Agenda
Village of Arlington Heights
Design Commission
Community Room, 3rd floor
Arlington Heights Village Hall, 33 S. Arlington Heights Rd.
September 24, 2019
6:30 PM

**Design Commission
9/24/2019**

MINUTES OF
THE VILLAGE OF ARLINGTON HEIGHTS
DESIGN COMMISSION MEETING
HELD AT THE ARLINGTON HEIGHTS MUNICIPAL BUILDING
33 S. ARLINGTON HEIGHTS RD.
SEPTEMBER 10, 2019

2 NORTH ELEVATION
1/4" = 1'-0"

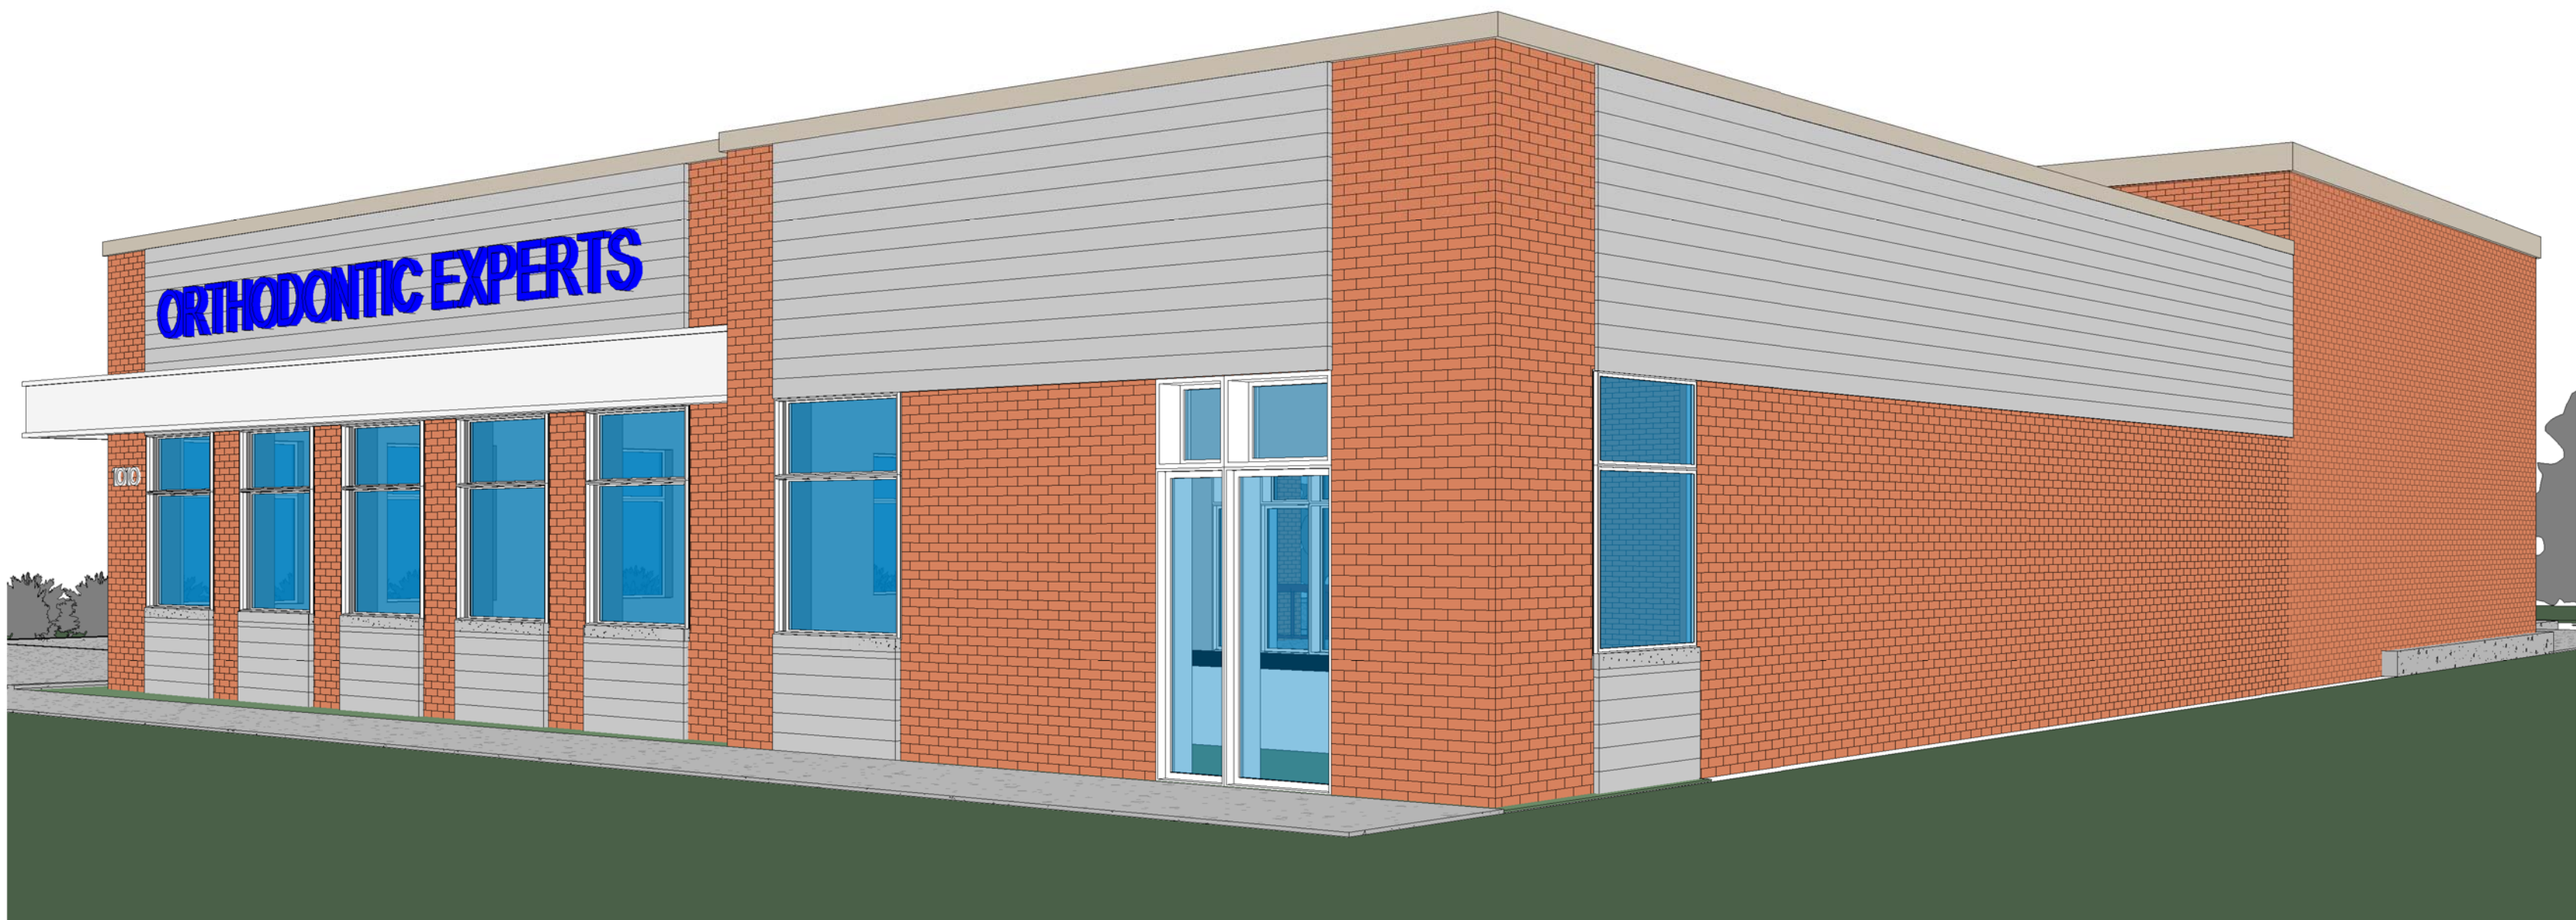
Chair Fitzgerald said his bigger concern was with the north elevation that abuts the adjacent parking lot and has no architectural detail. This elevation will be extremely visible from Arlington Heights Road, and although the proposed addition and renovation is a great improvement to the existing building, he felt this was a missed opportunity to do some type of detailing on the north elevation. He wanted to hear the petitioner's comments about this. Chair Fitzgerald also agreed with Staff's comments on the landscaping, and said he was very much against the red mulch.

7. A REQUIREMENT THAT THE PETITIONER STUDY THE MASSING OF THE NORTHEAST CORNER TO MAKE IT MORE SOLID, IF THE AESTHETICS OF THE ELEVATION WOULD DICTATE, TO BE SUBMITTED TO STAFF FOR THEIR COMMENT AND EVENTUALLY THE DESIGN COMMISSIONERS' REVIEW.
